BENSON-MONTIN-GREER DRILLING P&A Procedure

Well Name: EPCMU #14 (N-19) API Number.: 30-039-82247

Re: Permanent Abandonment Well: 14 (N-19) East Puerto Chiquito Mancos Unit

CONDITIONS OF APPROVAL

Benson-Montin-Greer Drilling Corp. Proposed Wellbore Diagram

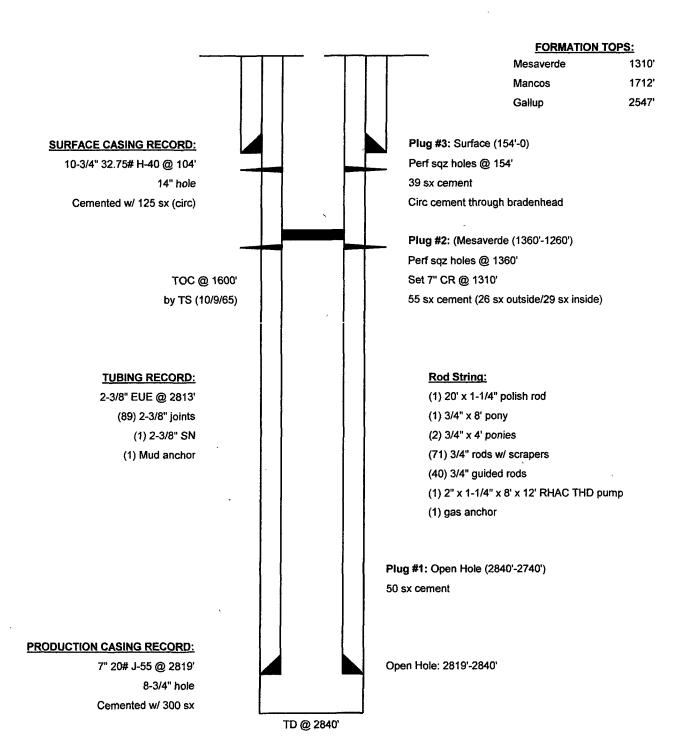
- 1. Plugging operations authorized are subject to the attached "General Requirements for Permanent Abandonment of Wells on Federal and Indian Lease."
- 2. Farmington Office is to be notified at least 24 hours before the plugging operations commence (505) 599-8907.
- 3. The following modifications to your plugging program are to be made:
- a) Bring the top of the Gallup plug to 2496'.
- b) Place the Mesaverde plug from 1315' 1215' inside and outside the 7" casing.
- c) Place the Surface plug from 164' to surface inside and outside the 7" casing.
